DX01

### DUST EXTRACTION SYSTEM

(For Model LXRH01, LXRH011, LXRH01Z,  
DHR242Z, DHR242RFEV, DHR242RMEV,  
DHR242ZVX)

**SERVICE CHANGES**

**Type 1**

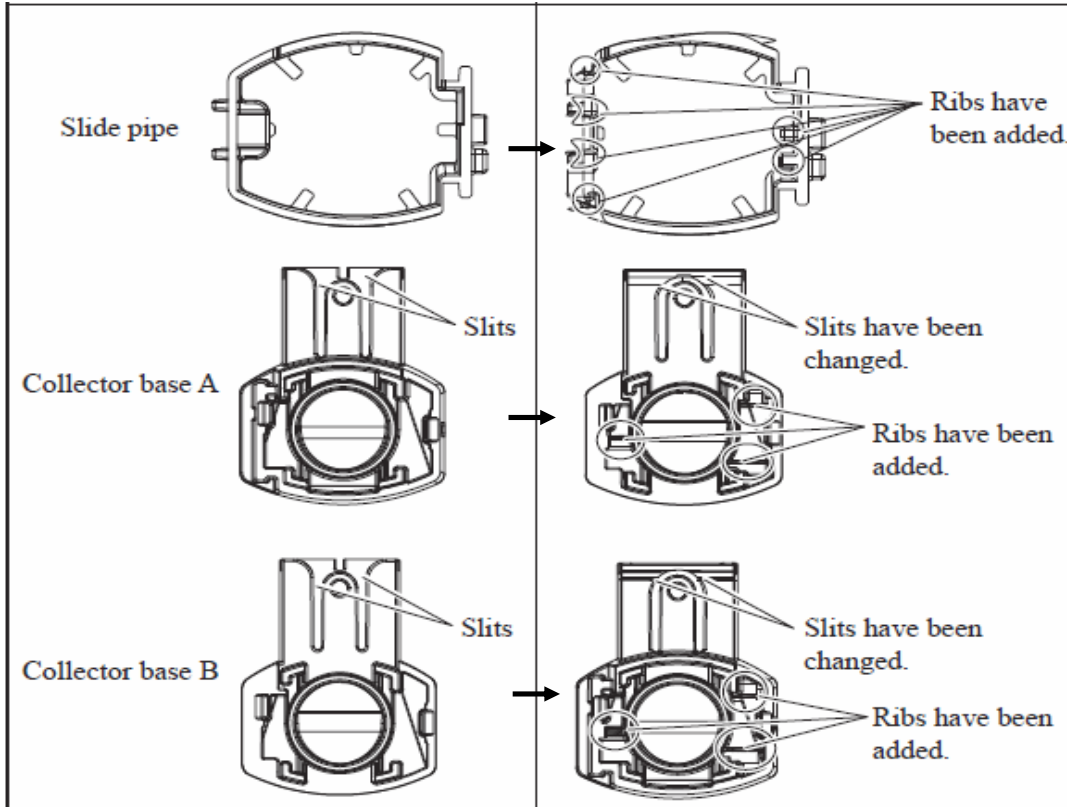
**1. Changes on Slide Pipe Assy**

(TI# 99363 )

Item No.	Description	Type 1	Type 2	Type 3	Type 4
40	SLIDE PIPE ASSEMBLY	135512-5	135565-4	135671-5	135696-9
1	FITTING RUBBER		424480-0		424722-2
3	COLLECTOR		453136-8		455736-0
4	COLLECTOR BASE A	453134-2		454578-9	
5	SLIDE PIPE	453137-6		454580-2	
7	INNER PIPE		453138-4		456017-5

Item No.1, 3, 4 - 7 are component of Item No. 40 Slide Pipe Assy

Above parts are completely interchangeable as a set.

**Type 3**

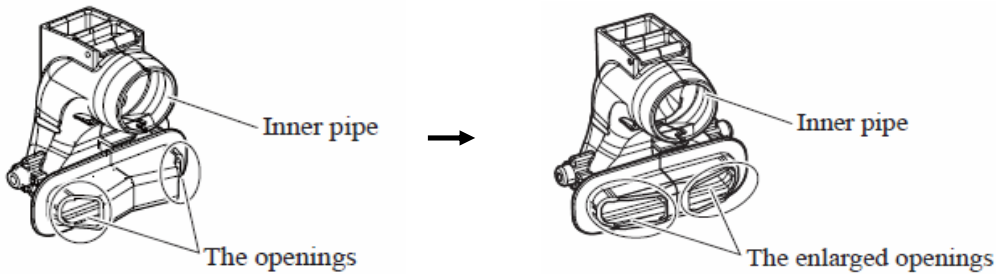
(TI# 99363 )

**Type 4**

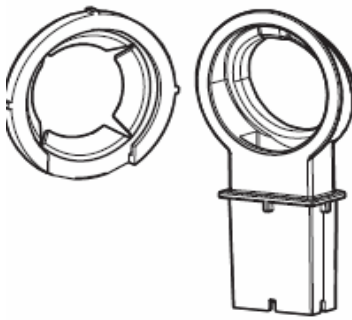
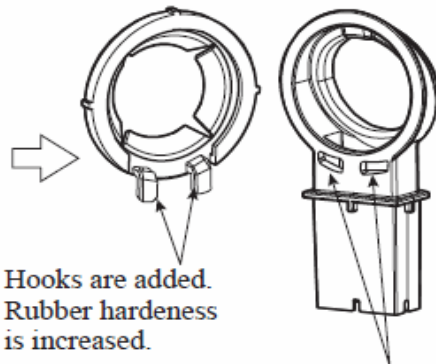
(TI# A9260)

Hooks are added.  
Rubber hardness  
is increased.

Square holes are added.

Insert the hooks of Fitting rubber  
into the square holes of Collector,  
and then turn Fitting rubber.
